RE: Ore Peninsula Redevelopment Project, Pacific Pile & Marine
Change Order No. 005

Date: March 5th 2024

Scope of Changes (Change Order 005):

Subject: Ore Peninsula Redevelopment Project
RFP – Upland Slab – PCO 003

DRAWN: JH	PROJECT NO.: 2100135
DESIGN: ED	SCALE: AS SHOWN
CHECKED: RR	DATE: 07/21/2023
DRAWING NO.	S3.24
SHEET NO.	184 OF 381

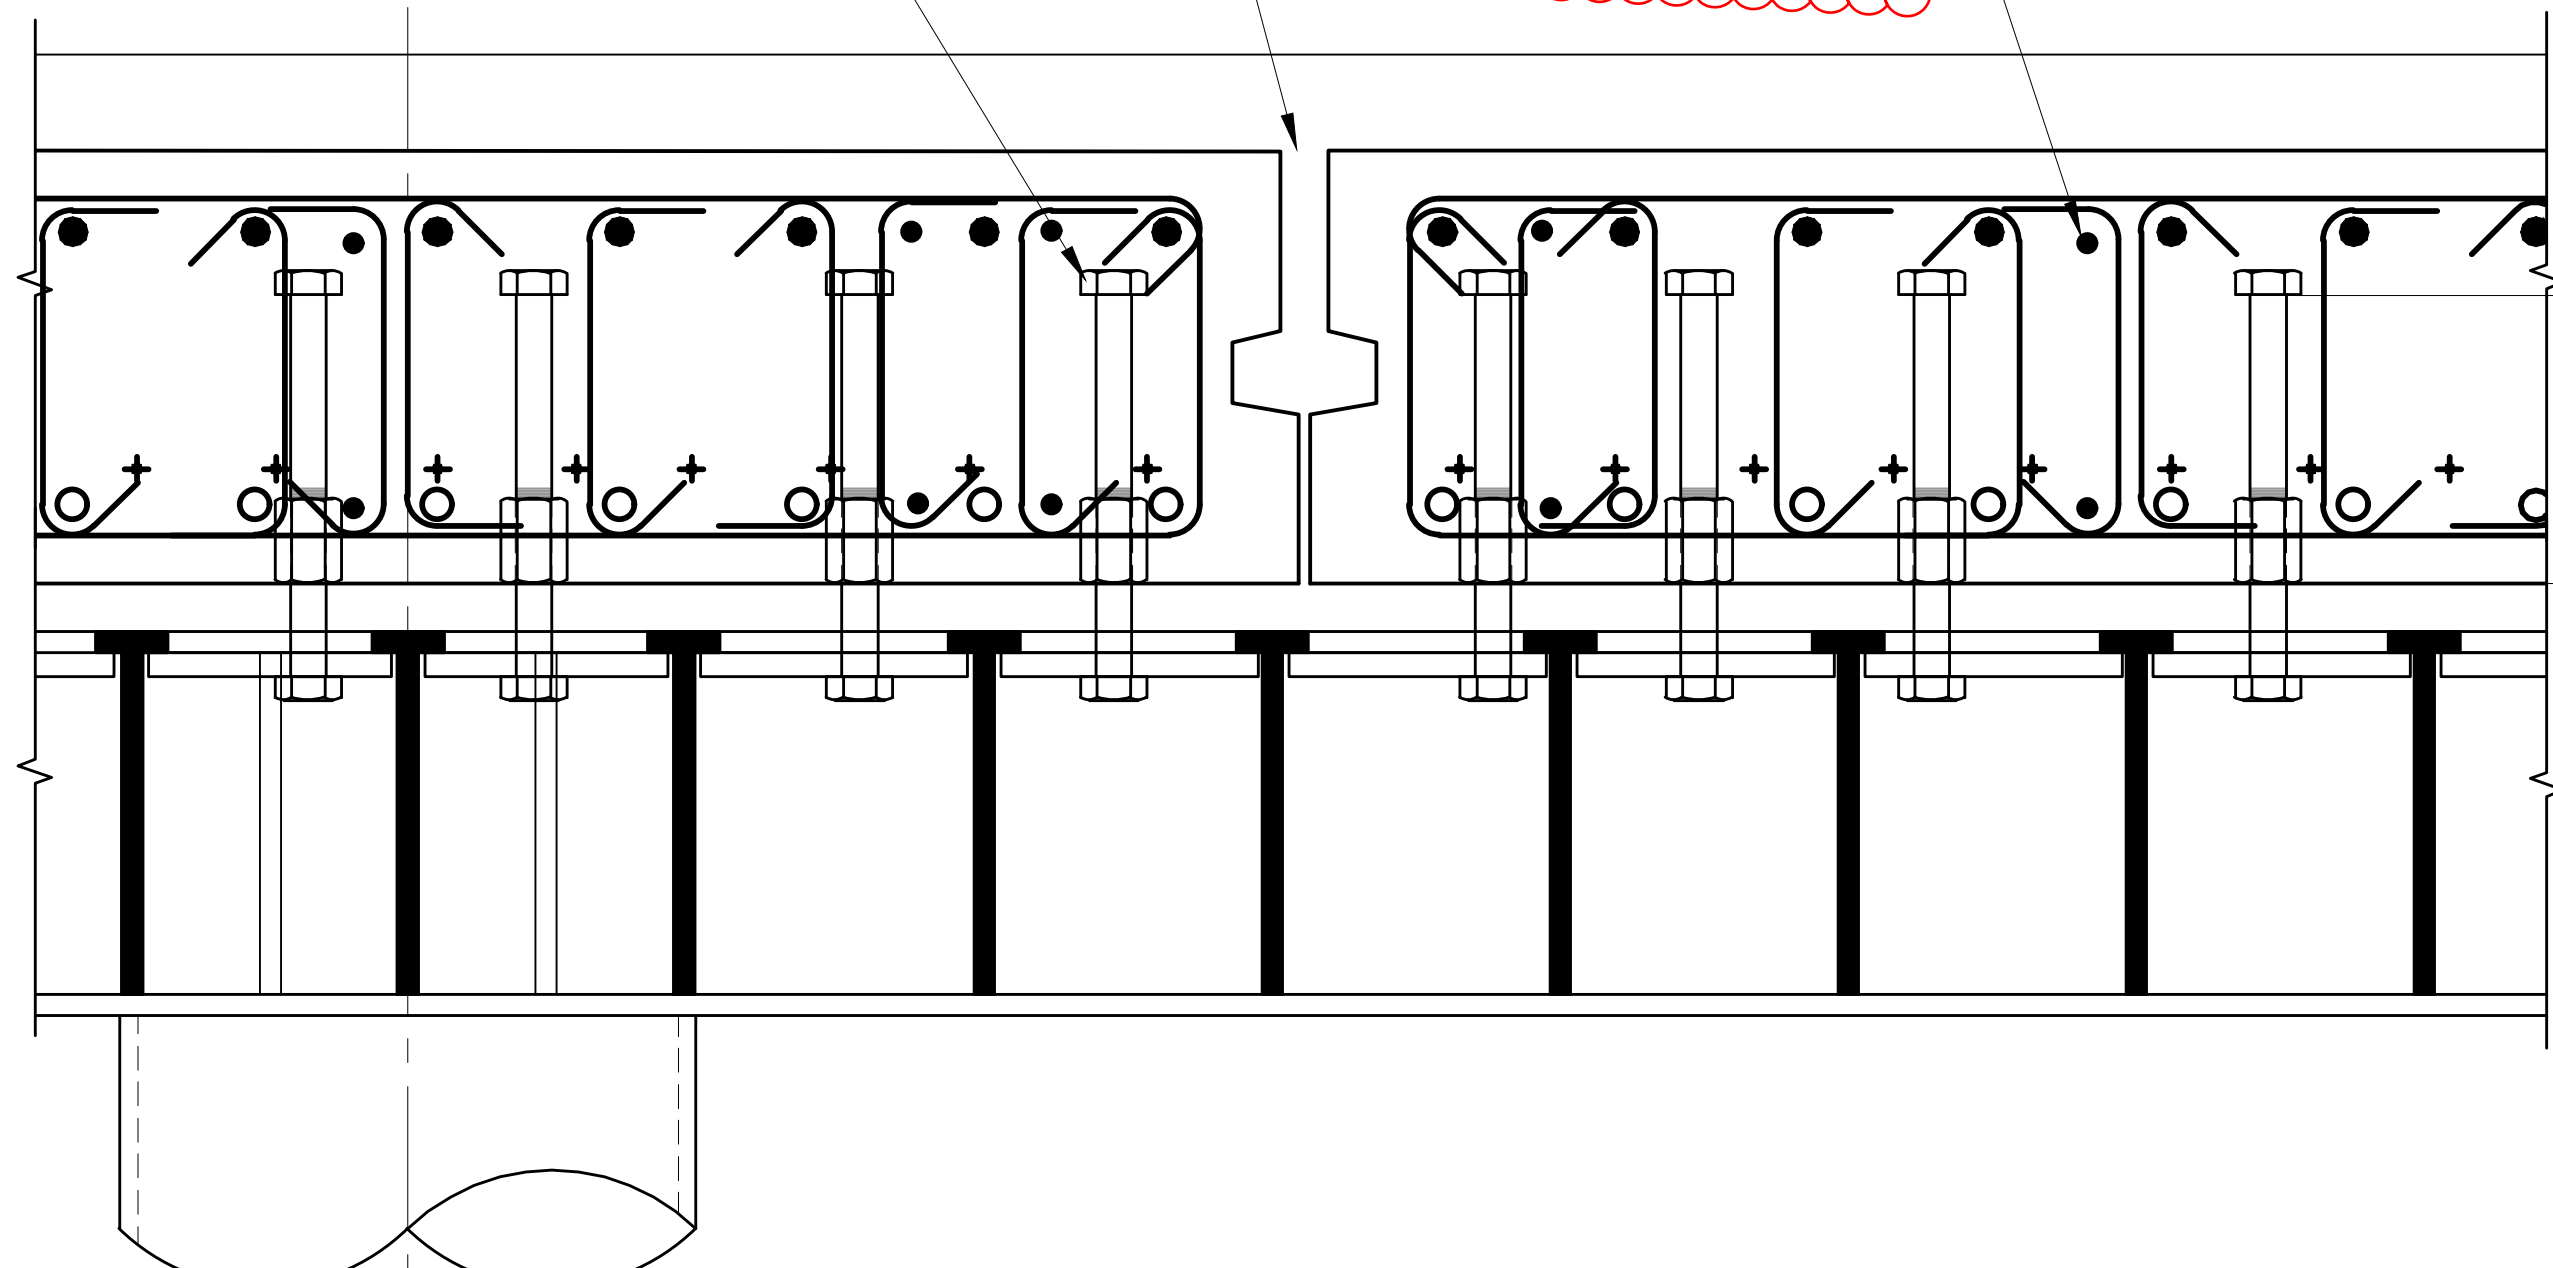
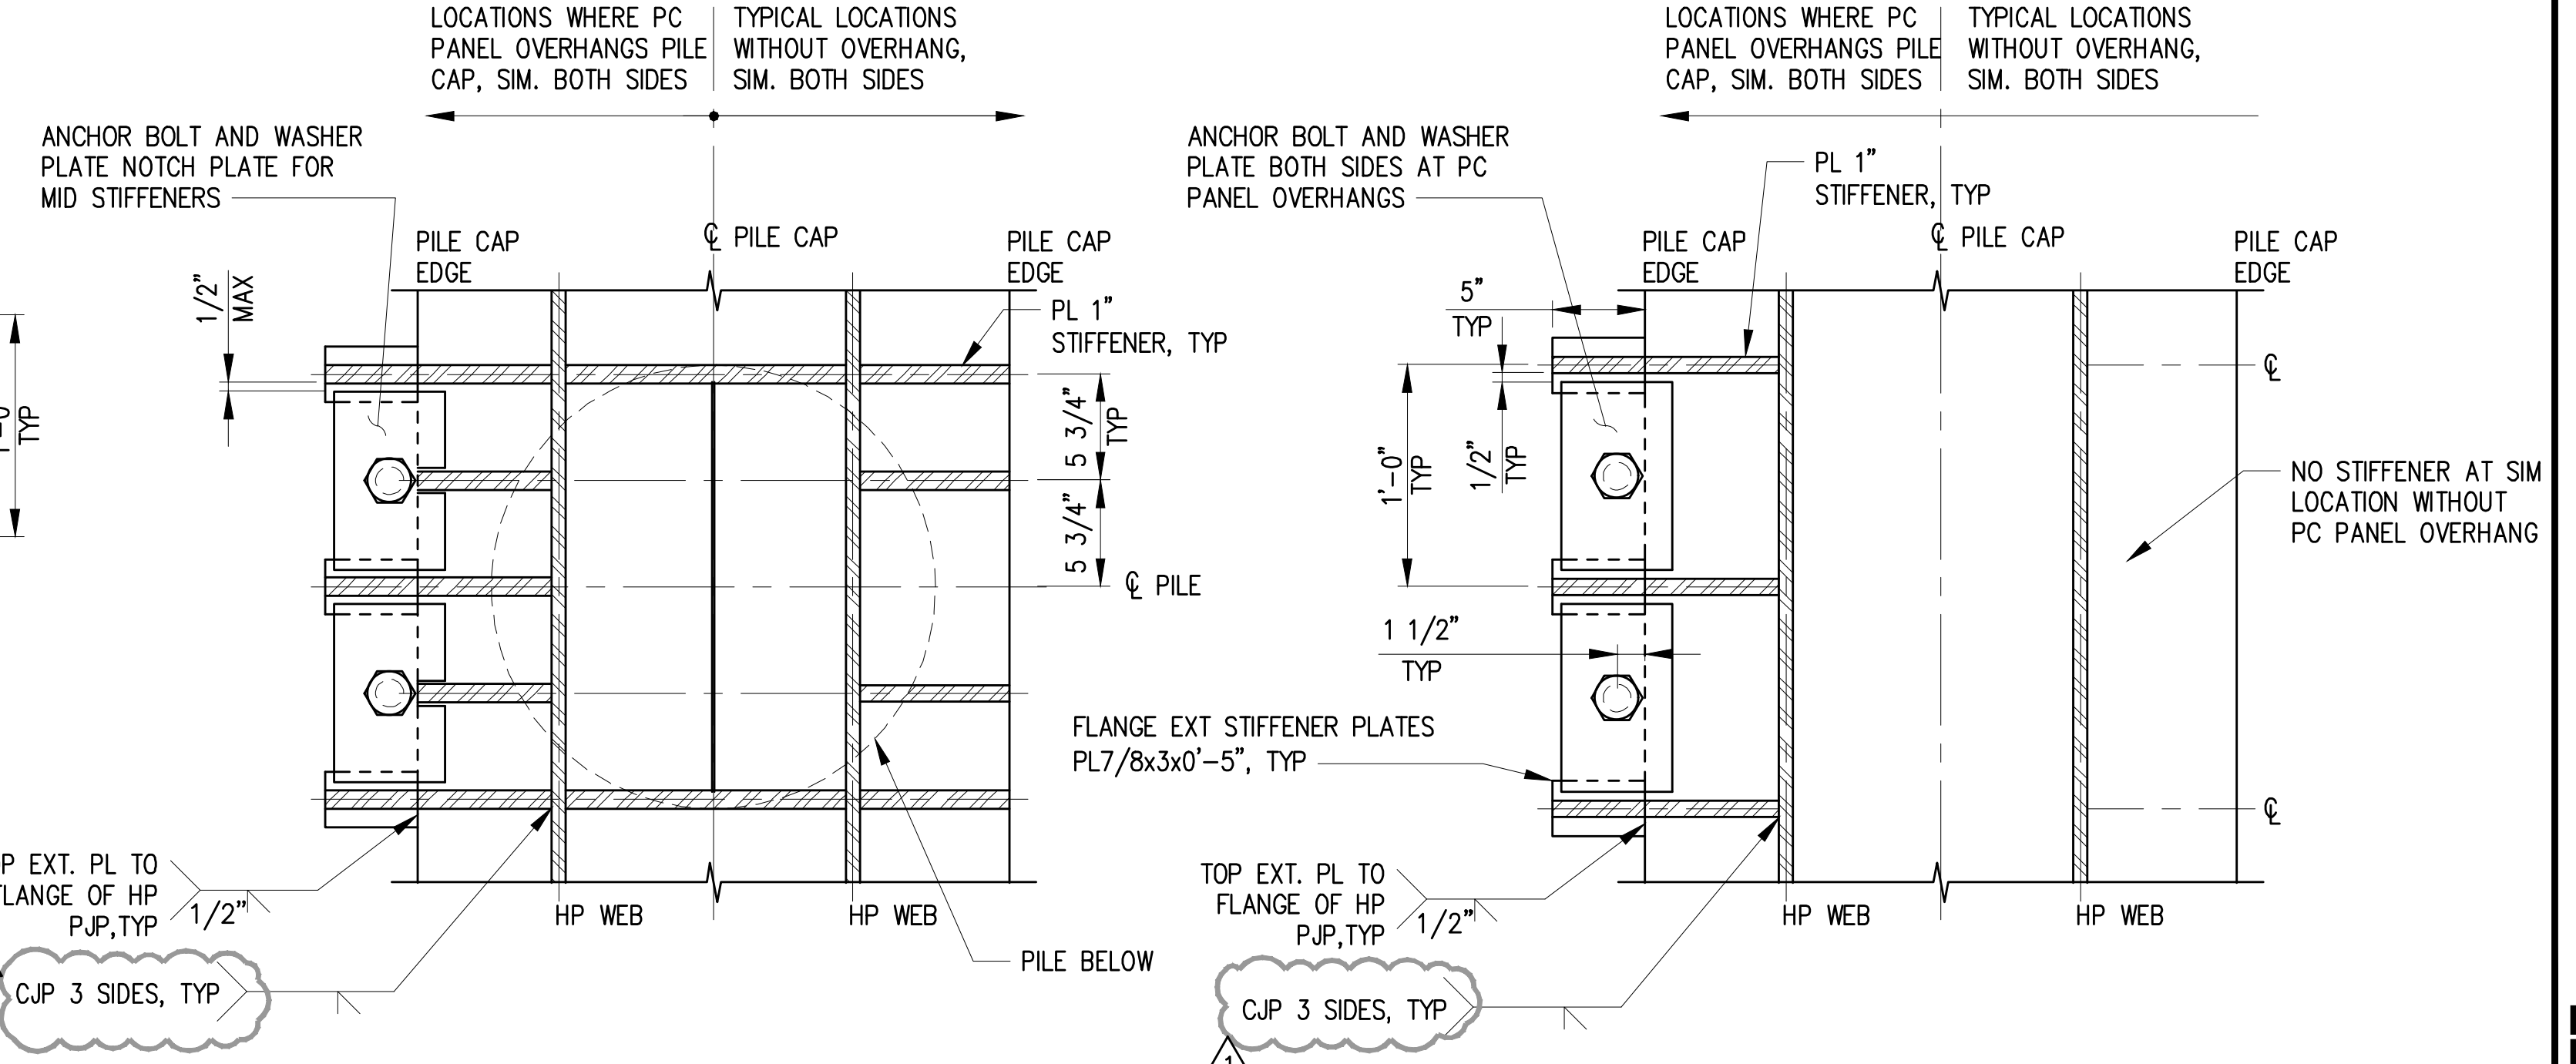
Hold-Down Bolts and Stiffeners - Additional (72) hold-down bolts and stiffeners to cover both sides of the pile caps as well as the 4 bolt connection at each pile location per IFC drawing S3.24
Headed Bar Spacing - Additional (140) headed studs to accommodate 7" OC spacing as shown on Detail A S3.24 and clarified in RFI 005.
Additional detailing costs - Additional detailing required for multiple shop drawing iterations to account for PCO 021 design changes.

Per RFI 005: grout tube - sizing and projection - CTC coordination with PPM

Per RFI 004: Use of an all around 5/16" Fillet Weld for attachment of the #7 or #8 sized Headed Rebar to the HP Pile Caps is acceptable.

Per RFI 005: KPFF Sketch clarifies the spacing requirements for these bolts

Clarifying details provided in RFI 005 Sketch provided by KPFF

RFI 005 RESPONSE Skagway	PROJECT NO.: 2100135	SHEET NO. 1 OF 2
	DATE: 2023-08-14	
	BY: DMR

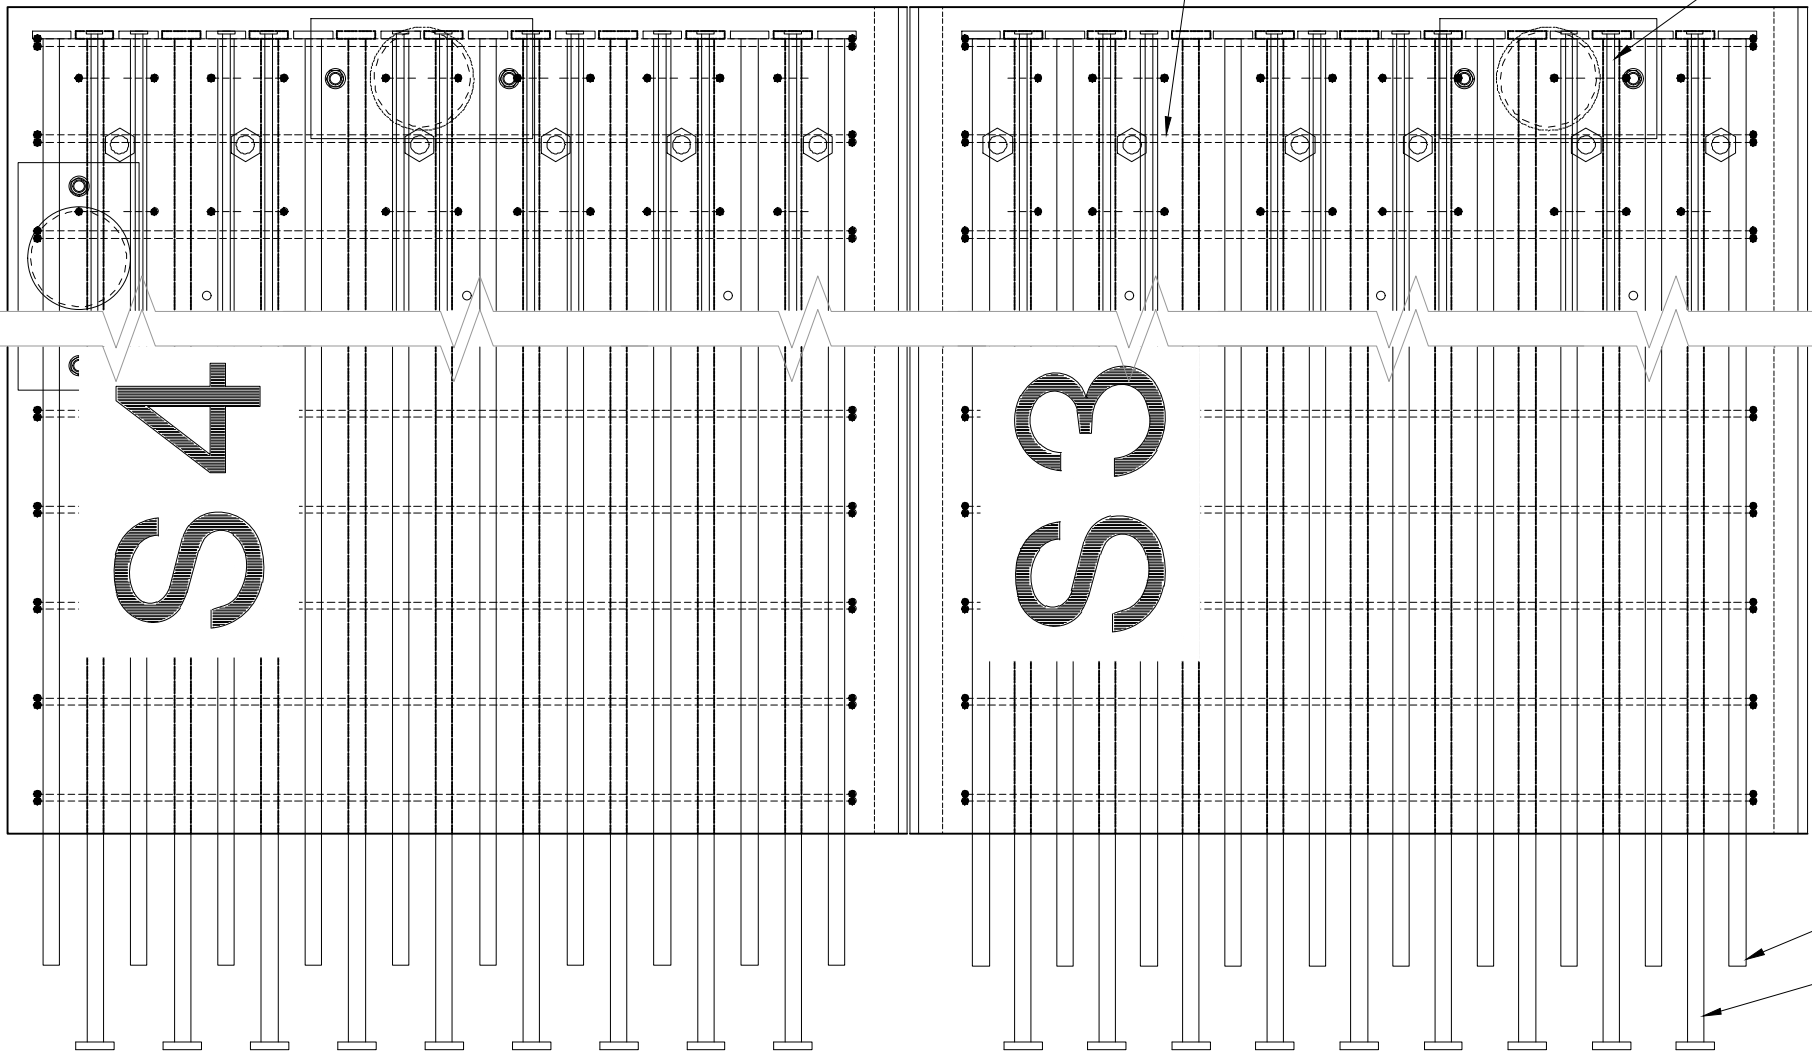
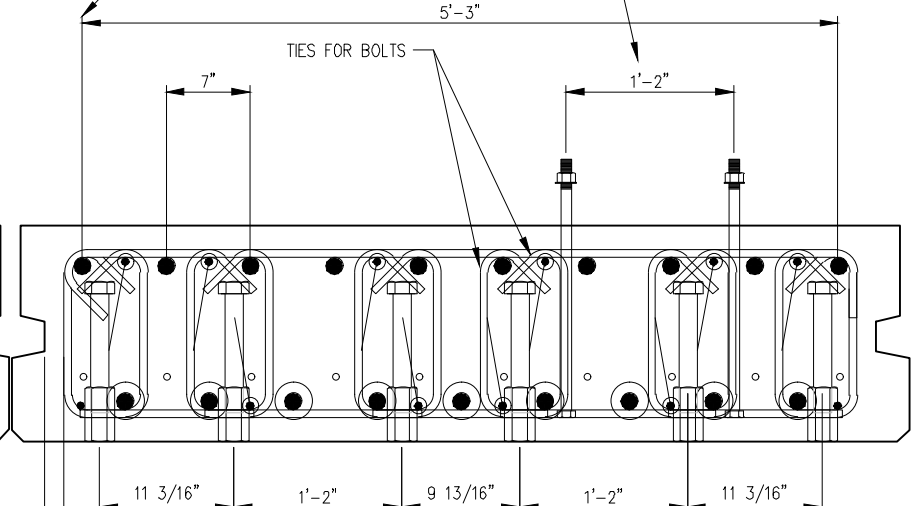
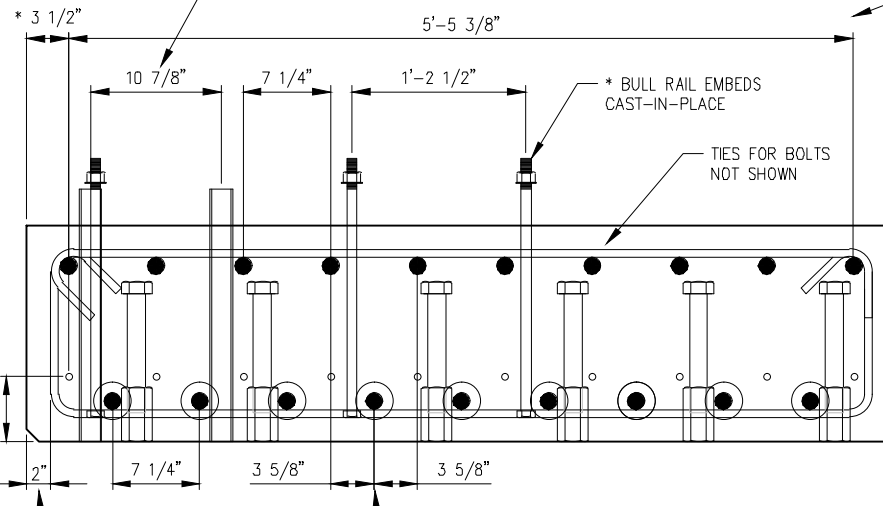
MINOR SPACING ADJUSTMENTS TO TYPICAL PANEL TIES IS REQUIRED TO ACCOMMODATE EMBED LOCATIONS

NOTED "ADDITIONAL" BARS SHOWN WITH HEAD ON ONE SIDE AND HOOK ON OTHER DUE TO CONGESTION AT END OF PANEL, HOOK-HOOK OR HEAD-HEAD AT CONTRACTORS OPTION

NOTED "ADDITIONAL" #5 FOR TIES WHERE THERE IS NO TOP OR BOTTOM BAR

ITEMS AND DIMENSIONS WITH "*" INDICATE INFORMATION NOT PROVIDED OR CHANGED

* MODIFIED GAUGE ON WINDSCREEN PVC SLEEVES, SLEEVES CHANGED TO 1-1/2" PVC TO ACCOMMODATE REBAR SPACING

PANEL ANCHOR BOLT SPACING IS TO AVERAGE AS CLOSE AS PRACTICAL TO 12" O.C.
